# Southampton to London Pipeline Project

Response to Action Points from the Issue Specific Hearing  
on Environmental Matters on 3 December 2019 (ISH2)

Application Document: 8.20

December 2019

Action No.	Action:	Applicant response to Action:
		<p><b>Figure 1.1 – Stringing and Open Trench Area at Queen Elizabeth Park</b></p>

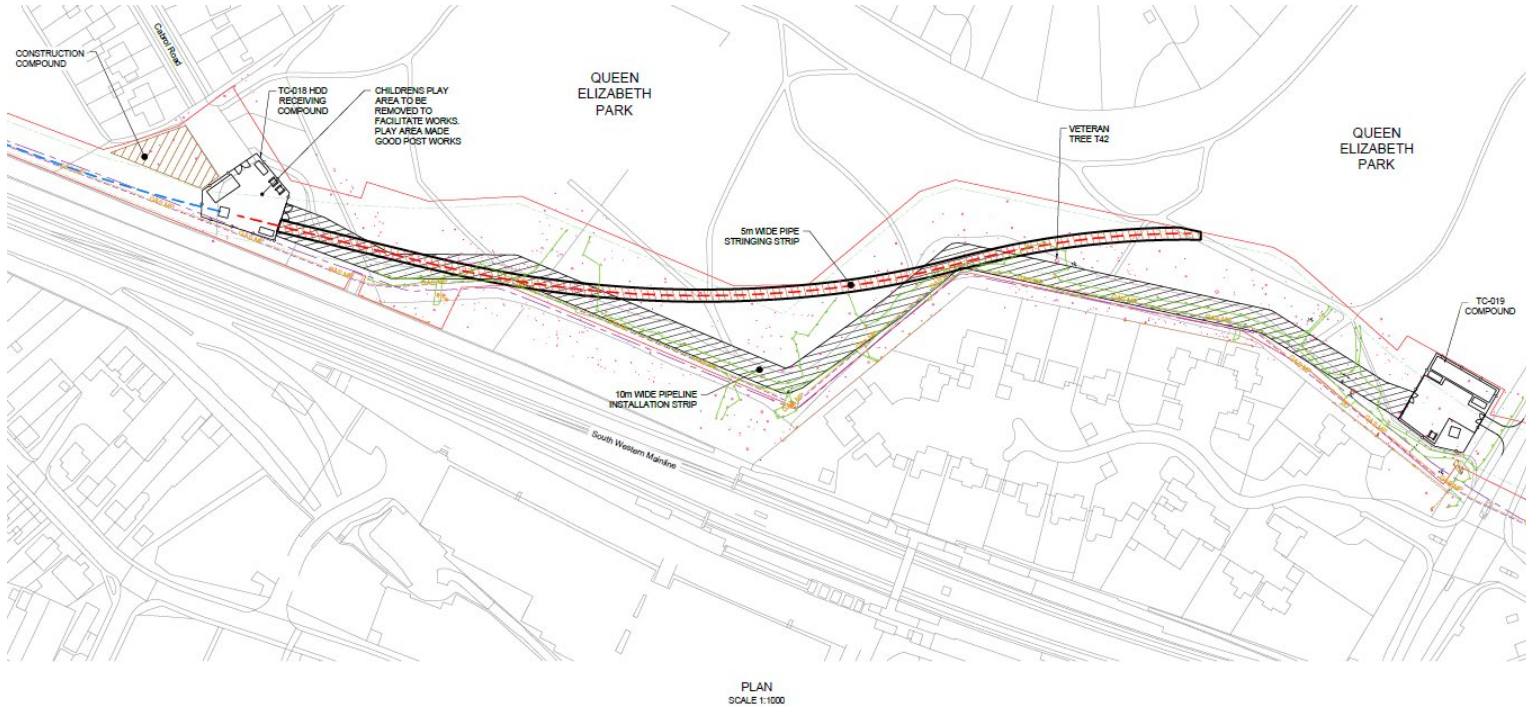
Action No.	Action:	Applicant response to Action:																
		inform the Arboricultural Management Plan secured as Requirement 6(2)(d)(ix) in the draft DCO ( <b>Document Reference 3.1 (4)</b> ).																
7	Provide detail of the number of trees and the species of trees that would be lost in Queen Elizabeth Park – either in LEMP or Construction Environmental Management Plan (CEMP) or signpost to where this information has been provided	<p>The tree survey of the intended working area within Queen Elizabeth Park as shown below was completed on 13 December 2019. The Applicant has initially identified 28 mature trees within the intended working area as shown in the Table 1.1 and Figure 1.1 below. The Applicant intends to retain as many of these mature trees as possible but further work is required to ascertain which trees may need to be removed.</p> <p>The final tree survey report and an assessment of the trees that may need to be removed will be submitted at Deadline 4 and will be included in the outline CEMP.</p> <p><b>Table 1.1 Species of mature identified</b></p>

Action No.	Action:	Applicant response to Action:
		<p><b>Figure 1.2 – Narrow Working and Stringing Out Areas through QEP</b></p>

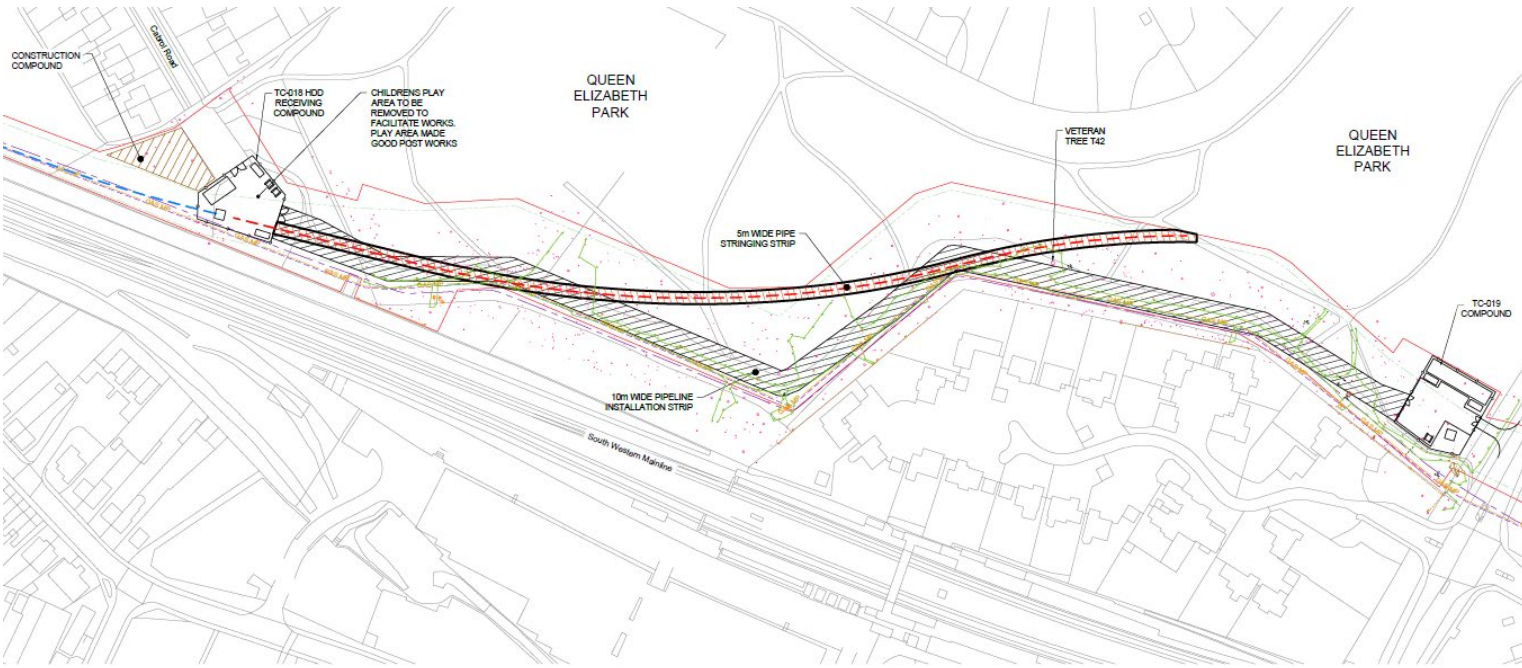
Action No.	Action:	Applicant response to Action:
	Consent Order (dDCO) this access would be secured	
10	Provide a written note on the approach to trees in Queen Elizabeth Park including the results of the current tree survey work and in light of the proposed outline LEMP	<p>The Order Limits were selected to avoid the northern section of the park in which the woodland consists of a greater number of more mature and notable trees, while in the southern section of the park the trees are more variable in age and are largely choked with dense areas of Rhododendron, an invasive non-native species that Rushmoor Borough Council has been endeavouring to eradicate.</p> <p>The approach to trees in Queen Elizabeth Park was initially informed by a tree walkover survey as outlined in Chapter 10 of the ES (<b>Application Document <a href="#">APP-050</a></b>). Paragraph 10.2.20 explains that ‘...a <i>targeted approach to the tree survey was undertaken by arboriculturists to record information about notable trees within 15m of the Order Limits. Notable trees are defined as prominent trees within the landscape and by nature will generally be the larger more mature specimens. Notable trees were assessed as Category A and B trees during the arboricultural survey, using the grading definitions within British Standard 5837:2012...</i>’ The approach aims ‘to capture tree data on woodlands, veteran/ancient trees and notable/mature trees that are likely to be lost or affected by the Project’ (Chapter 4, Paragraph 4.2.1 of Appendix 3 of the Scoping Report) (<b><a href="#">AS-019</a></b>).</p> <p>The Notable Trees were shown on ES Figure 10.3 (<b>Application Document <a href="#">APP-050</a></b>) (Sheet 9) and noted in ES Appendix 10.2 (<b>Application Document <a href="#">APP-115</a></b>) which were submitted at the application. Notable Trees Plan (Sheet 41 and Sheet 42) were then submitted with the Applicant’s response to the ExA’s First Written Questions (<b><a href="#">REP2-045</a></b>). The plans show the location of notable trees within Queen Elizabeth Park that were surveyed to inform the application.</p> <p>This was supplemented by the bat survey which assessed all trees for their potential to be used as bat roosts (<b>Application Document <a href="#">APP-087</a> / <a href="#">APP-088</a> / <a href="#">APP-089</a></b>)</p> <p>These surveys helped to inform the project design and led to the decision to adopt narrow working in Queen Elizabeth Park. This ensured that the maximum working width would be 15m through the wooded section of the park, thus reducing the amount of woodland affected, although the level of design meant the exact location of the narrow working could not be confirmed.</p>

Action No.	Action:	Applicant response to Action:
		<p>Further design work has resulted in the project's intention to install the open trench section of the pipe in an alignment that largely follows the existing pedestrian and cycle path on the south side of the park. This working area for the pipe installation would be limited to a 10m wide working area to limit the impact on trees found on either side of the path. This intended route would mean that a significant percentage of the working area is already free of trees due to the presence of the path, the street lighting and adjacent verges to the path.</p> <p>As explained in the Technical Note: Ancient Woodland and Veteran Trees (<a href="#">REP2-061</a>), <i>'At the time of submission of the application for Development Consent, there were no veteran trees recorded on the inventory within 15m of the Order Limits.'</i> However, since the application two veteran trees within 15m of the Order Limits in Queen Elizabeth Park have been added to the Woodland Trust Ancient Tree Inventory.</p> <p>The Applicant's approach to veteran trees explained in the Technical Note: Ancient Woodland and Veteran Trees (<a href="#">REP2-061</a>) means, where the pipe cannot be installed outside of a Veteran trees' Root Protection Area (RPA), site-specific measures that would be employed to mitigate the effects on the RPA, for example hand digging/vacuum excavation under arboricultural supervision. These would be recorded in a method statement.</p> <p>The other 5m of the 15m narrow working area would be required for 'stringing' out pipe to facilitate the trenchless installation of the pipe west towards Stake's Lane. This pipe will be laid out on rollers above ground and is not expected to require the removal of any trees beyond those required for the open trench installation.</p> <p>In order to update the tree survey data submitted with the application, the Applicant has recently completed a supplementary tree survey to BS5837:2012, picking up all trees with a stem diameter of 75mm and above, based on topographic survey to provide a greater degree of accuracy for the park. The survey site works were completed on 16 December. The Applicant is currently preparing the final report, which will be submitted at Deadline 4.</p> <p>The supplementary tree survey details will be used to inform the detailed design of the pipeline and the mitigation measures.</p> <p>Following discussions with both Officers and Ward Councillors from Rushmoor Borough Council, the Applicant will remove the Rhododendron within the working area as this is a non-native invasive species.</p>

Action No.	Action:	Applicant response to Action:
11	Provide written response to clarify the situation with regards to tree removal where stringing out would occur ie would trees need to be removed or could they be retained?	<p>The Applicant will utilise a methodology for the stringing-out area which will limit the amount of vegetation and tree removal required by creating a 'workshop' area. The pipe will be delivered adjacent to the workshop area. This area will then be used to weld together pipes (12m long). As more pipes are added to form into a single long length the 'string' will be gradually drawn out, on a series of rollers and pipe supports, by means of small machinery such as six-tonne excavators and mobile power cable winches placed along the length of the stringing area. This technique will limit the need to clear wide areas and the pipe string will be able to snake around to avoid large trees and obstructions.</p> <p>In Queen Elizabeth Park the workshop would be located in the construction compound in the former playground area, and the pipe string (approximately 450m in length) would be positioned across the park such that large trees can be retained. The intended stringing area is shown on the sketch below (Figure 1.2) and would be further informed by the arboricultural survey.</p>

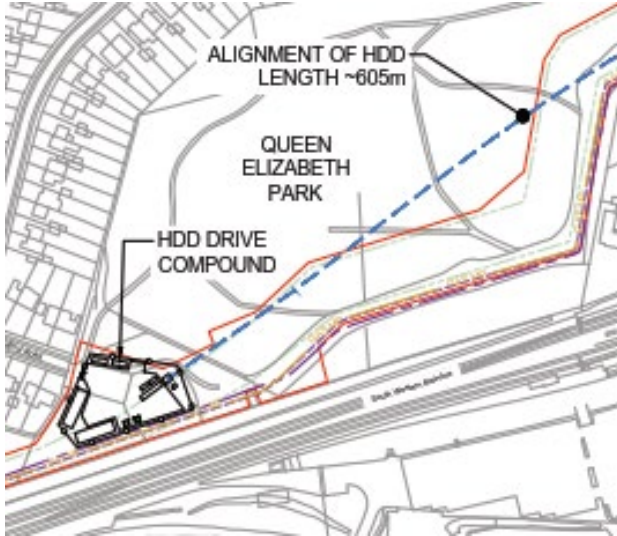
Action No.	Action:	Applicant response to Action:
	cut a new trenchless section from Queen Elizabeth Park trenchless drill site in the play park to Farnborough Hill School going under most of the park and the A325 could be used	<p>The Applicant has endeavoured to accommodate the route, however as noted below the option of using a HDD trenchless method (Option 1 &amp; 2) would be less favourable as detailed below.</p> <p>In selecting the installation method in any location along the route the Applicant has had to take into account a range of considerations. The default method for installing the pipe is using open trench because this is the quickest method and provides the greatest level of certainty of delivery. The use of trenchless techniques requires working at much greater depths and regardless of ground investigation surveys there is always the risk of encountering difficult unknown geology which can cause delays and even failure of the HDD and the need to open trench.</p> <p>In addition the Applicant has compared the issues and impacts related to using trenchless techniques with the expected impacts of open trench.</p> <p>In QEP the Applicant believes that the intention to install the pipe adjacent to the existing cyclepath, to reduce the working area to 10m and its ability to retain a number of veteran and other mature trees, along with the reinstatement measures that had been agreed with Rushmoor's Officers and Elected Members, will deliver a better overall solution than a long HDD.</p> <p>The particular issues that relate to the alternative of an HDD from QEP to Farnborough Hill school are as follows:</p> <p>The HDD from Stake's Lane would still need to be strung out through QEP and this would involve some tree removal and disturbance to park users.</p> <p>Using the same location for an HDD to Farnborough Hill School would require the drilling area and compound in QEP to be present for a greater period of time which would delay reinstatement of the play area. In addition, for a HDD installation the compound area within QEP would need to be increased in size to accommodate all of the equipment associated with a HDD drill pit.</p> <p>To locate the HDD drive pit in this area of the park would require greater mobilisation of plant to the location, a larger drive compound and the potentially greater loss of trees in the south west corner. See Figure 1.3.</p>

**Figure 1.4 – HDD from play area in QEP to Farnborough School**

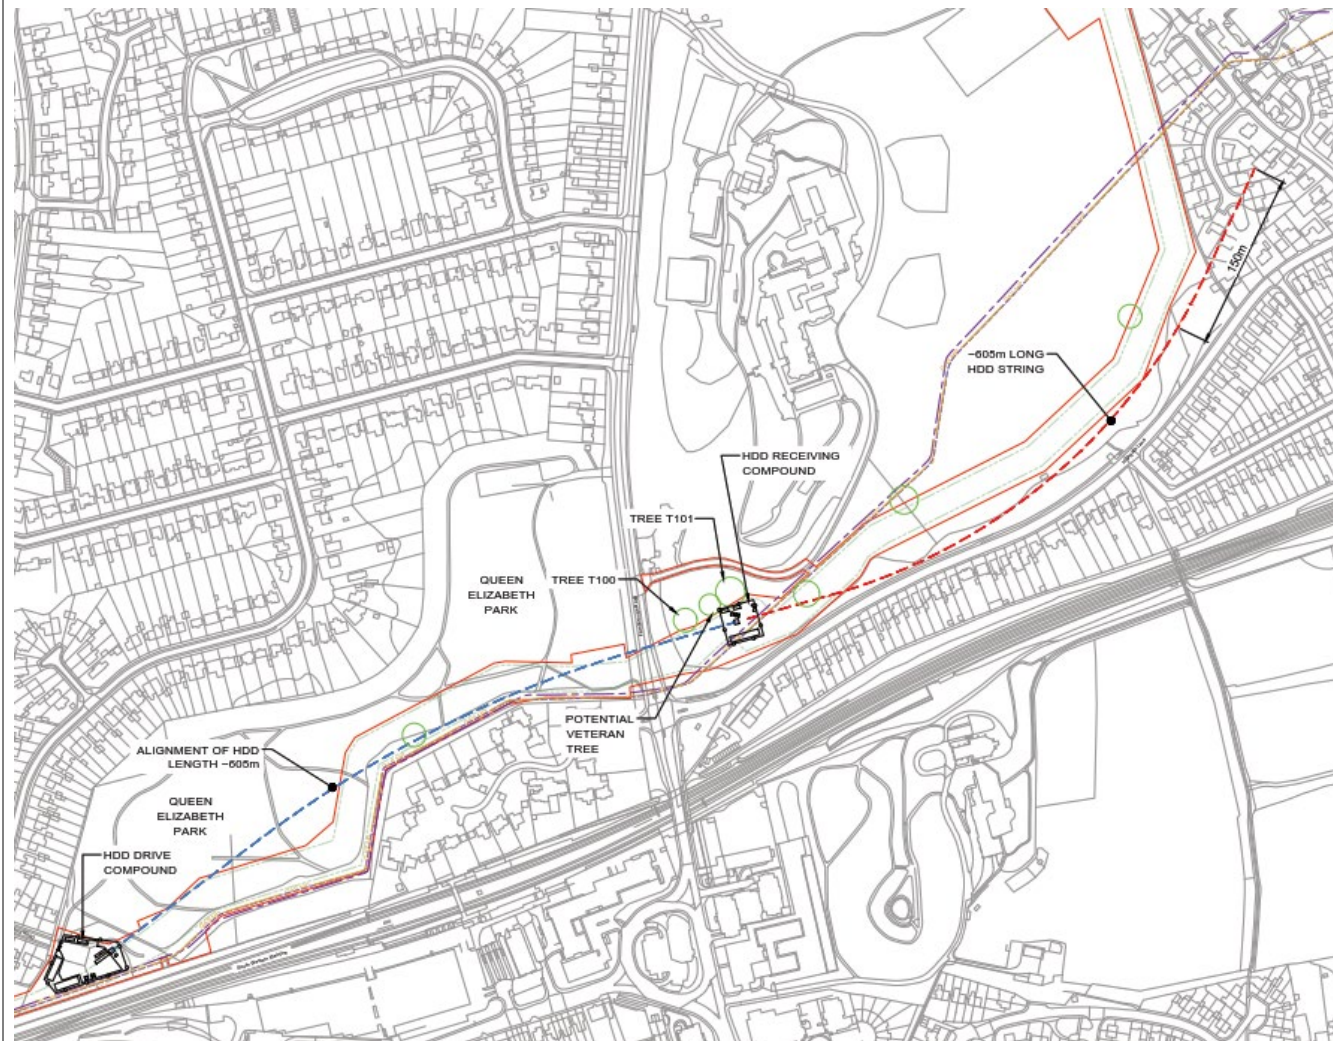
Action No.	Action:	Applicant response to Action:
		trench works around the perimeter of the grounds in a committed narrow working area, while also avoiding the band of notable trees. The stringing out area is unlikely to be able to take a similar alignment. (See options below).

Action No.	Action:	Applicant response to Action:
		<p>The Applicant has been engaging with the school and one of their early requests was that, if the Applicant was installing the pipe within the school grounds, that the route should follow the perimeter of the playing fields in a narrow strip. This narrow working still affords the school open access to the majority of the main field/ grounds during the school holidays, this would allow activities to continue to take place during this period. The stringing out area is unlikely to be able to take a similar alignment. (See options below).</p> <p>An assessment of each of the options is as follows:</p> <p>HDD Option 1- Referring to the sketch (Figure 1.4) above. In order to provide sufficient stringing out distance within Farnborough Hill School (approximately 600m) the receiving compound needs to be in a location within the school ground which would likely necessitate removal of a number of trees in the southern corner of the grounds - including two Veteran Trees. Even when utilising the maximum radius bend for stringing, the string layout is shown to be approximately 30m short of the required length. This shortfall could be accommodated by moving the start point in QEP further back, out of the play area and nearer to the south east corner of the park, which would result in further tree loss. This stringing alignment would also require encroachment on the school grounds.</p> <p>HDD Option 2 - Referring to sketch (Figure 1.5) below. In order to reduce the potential loss of Veteran Trees in the school, this refined layout positions the receiving compound in a location that does not result in the removal of Veteran Trees, however due to the change in alignment there is insufficient stringing length, approximately 150m short. The string could potentially be broken into two sections, however welding, testing, &amp; coating does take a number of days and whilst it is possible to restart a HDD string pull (it is standard practice to pull a string back in one continuous operation), it is has a higher risk of failure which could extend the installation period significantly and could require work to extend into the school term time.</p>

**Figure 1.6: Current understanding of Cabrol Road Surface Water Flood Risk based on RoFSW Mapping for 1 in 30 (dark blue) and 1 in 100 (light blue) events**

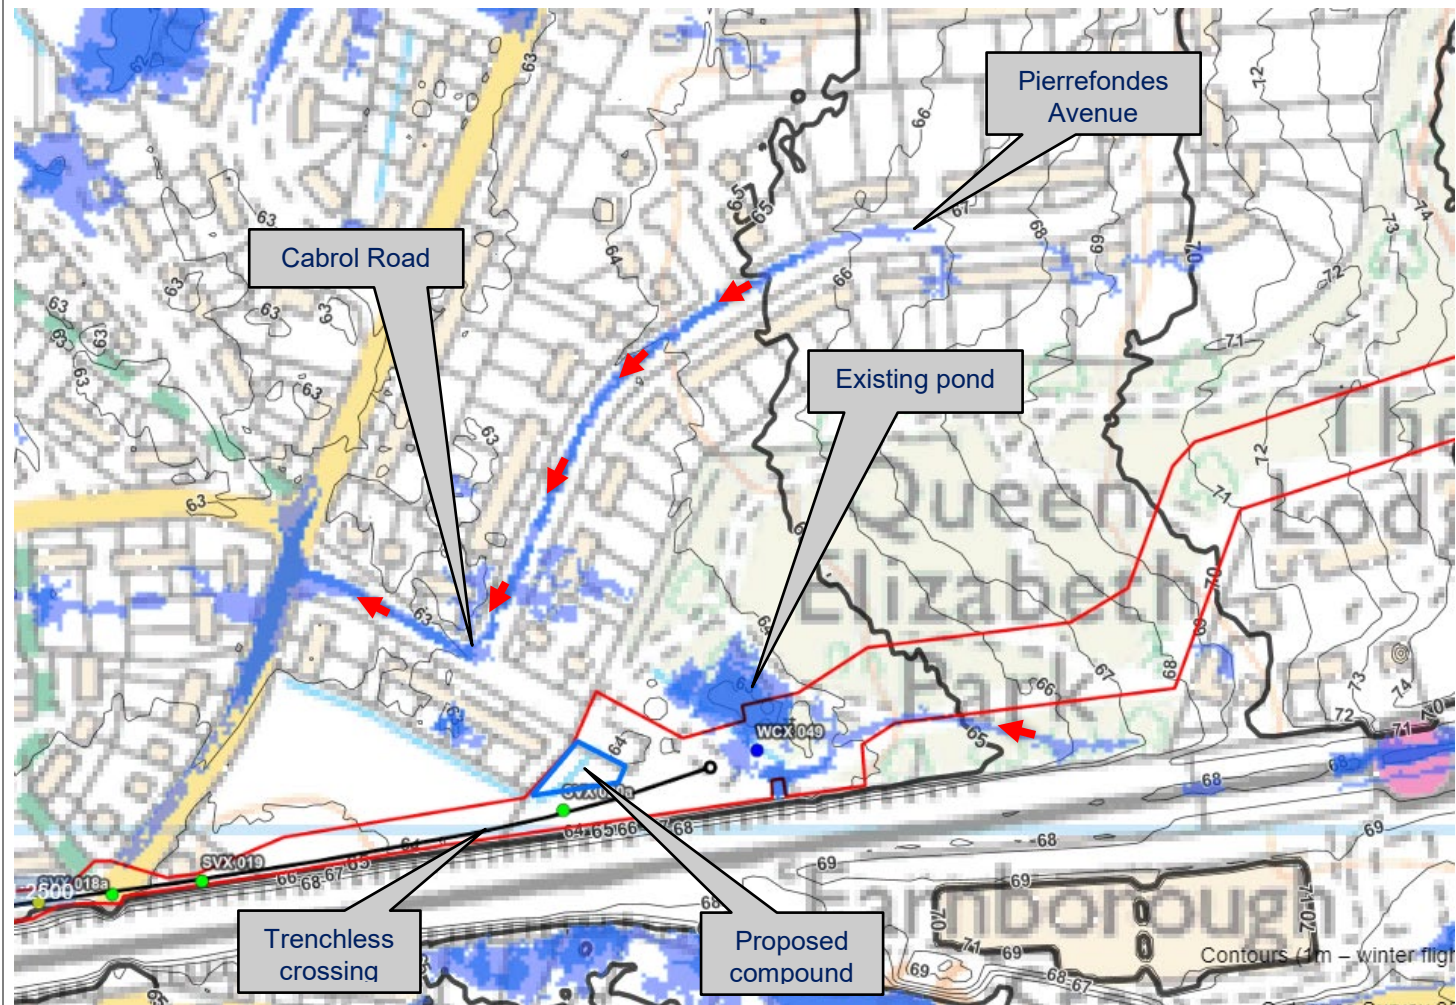
Action No.	Action:	Applicant response to Action:
	exacerbate this situation	<p>park. When considering the 1% (1 in 100 (Medium)) Annual Exceedance Probability (AEP) extent this flow path does not appear to extend into Cabrol Road.</p> <p>The Rushmoor Borough Council Strategic Flood Risk Assessment (SFRA) (2015), makes no reference to flood history in relation to Cabrol Road based on historic reports provided by the Environment Agency, Hampshire County Council or Rushmoor Borough Council.</p> <p>In terms of the project, there would be no above-ground infrastructure at this location to result in loss of floodplain at Cabrol Road during operation. There would also be no additional impermeable surfaces introduced during the construction phase.</p> <p>During construction the Applicant does not anticipate having an effect on the flood flow path along Pierrefondes Avenue. The southern flow path through Queen Elizabeth Park is less defined where it enters the Order Limits and the Applicant does not anticipate its work in this area contributing to flows. While the Applicant expects to remove some trees in the southern part of the park, removal of trees would not change the nature of the ground surface, and the ground would remain permeable. Therefore, the project would not change surface water runoff rates as a result of the removal of the trees.</p> <p>A number of commitments have been made by the project so that the installation of the pipeline does not affect flood risk. These include:</p> <ul style="list-style-type: none"> <li>• Commitment W5: <i>'Topsoil and subsoil would be stockpiled for as short a duration as practicable within Flood Zone 3 and areas of High and Medium RoFSW'.</i></li> <li>• Commitment W6: <i>'Stockpiles in Flood Zone 3 or areas of High or Medium RoFSW would not exceed 25m between breaks. Breaks in between stockpiles would be at least 5m. Breaks would be located opposite each other on either side of the excavation where practicable.'</i></li> <li>• Commitment G127: <i>'the contractor(s) would subscribe to the Environment Agency's Floodline service which provides advance warning of potential local flooding events and subscribe to the Met Office's Weather Warnings email alerts system. The contractor(s) would implement a suitable</i></li> </ul>

Action No.	Action:	Applicant response to Action:
		<p><i>flood risk action plan which would include appropriate evacuation procedures should a flood occur or be forecast'.</i></p> <p>The Applicant considers that with these measures in place, that the project would not increase flood risk to Cabrol Road.</p> <p>Red arrows in Figure 1.6 indicate predicted direction of overland flow based on the RoFSW mapping</p>

**Figure 1.7 – 10m Working Width Cross Section**

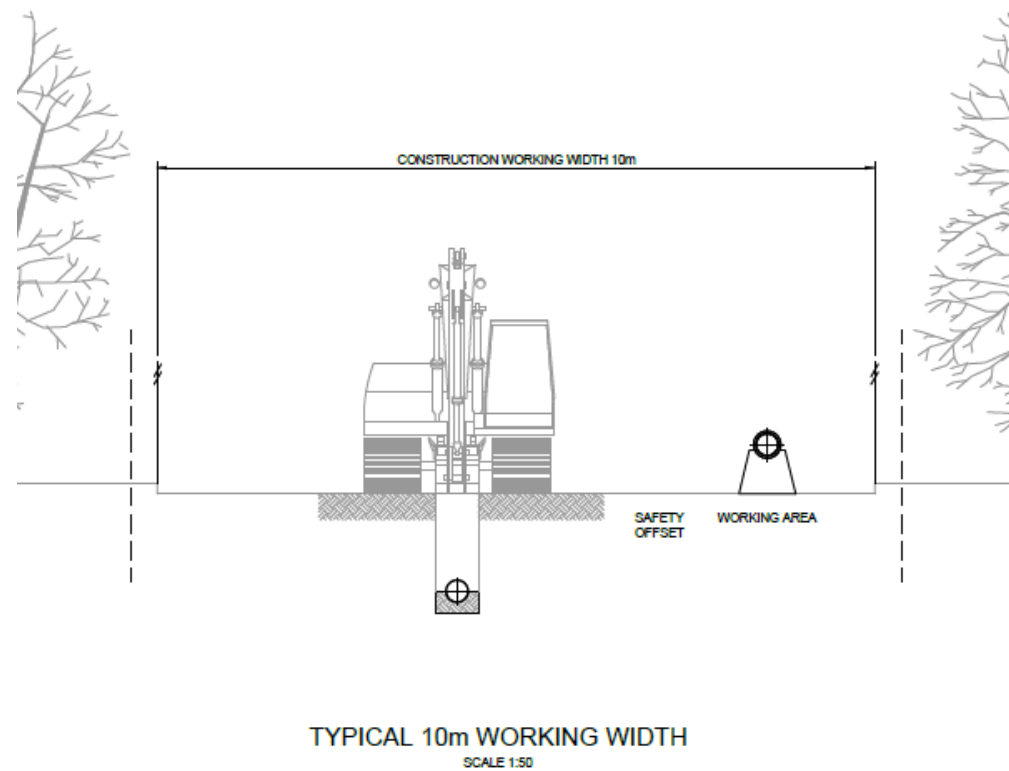
Action No.	Action:	Applicant response to Action:
		At Turf Hill, the F1a option follows an existing pathway through coniferous plantation woodland which is sub-optimal habitat for sand lizard. This would avoid the direct impact and complex mitigation required for sand lizard required for the F1b and F1c options. Further, the habitats along the central F1c route are used by the Special Protection Area (SPA) breeding birds, notably Dartford warbler, which breeds in gorse and heather, whereas the habitats along the F1a route are sub-optimal. Avoidance of the F1c route therefore also helps to reduce effects on habitats used by SPA breeding birds.
35	Provide a summary on route selection for Fordbridge Park and in particular why the route would go through the section of the park where the majority of trees are located rather than the adjacent area of open grass	<p>When selecting the route, the Applicant looked to avoid the area of open grass to the south and the existing utility corridor towards the north edge of the park. This maximises the amount of open space available in the park. In recognition of the trees in this area (including the memorial trees) the Applicant has introduced Narrow Working techniques which would weave around the trees and overhead powerline towers in the park.</p> <p>The narrow working area – NW30 in Fordbridge Park is 10m width. The Applicant has provided an alignment sketch below (Figure 1.7) which shows an indicative pipe alignment and narrow working width towards the southern extent of the LOD and skirting the edge of the majority of the trees. General narrow working principles are noted below:</p> <p>Narrow Working @ 10m:</p> <ul style="list-style-type: none"> <li>• Limited turf removal and topsoil strip, to the minimum to allow the pipe to be installed;</li> <li>• Extensive use of ground protection track/matting or similar, to minimise turf damage;</li> <li>• No backfill material stored in the work area;</li> <li>• Utilisation of appropriately sized machinery for the given working width – non-metal tracked machines and smaller excavators;</li> <li>• Site fencing to utilise non-intrusive water-filled or similar base fixings so as not to impact on the surface below;</li> </ul>

Action No.	Action:	Applicant response to Action:
		<ul style="list-style-type: none"><li>• In certain locations hand digging and other techniques will be required to reduce impacts in root protection areas; and</li><li>• Trenching boxes and temporary sidewall support to be used rather than battering back (sloping) of trenches, to reduce width of trench to a minimum.</li></ul>
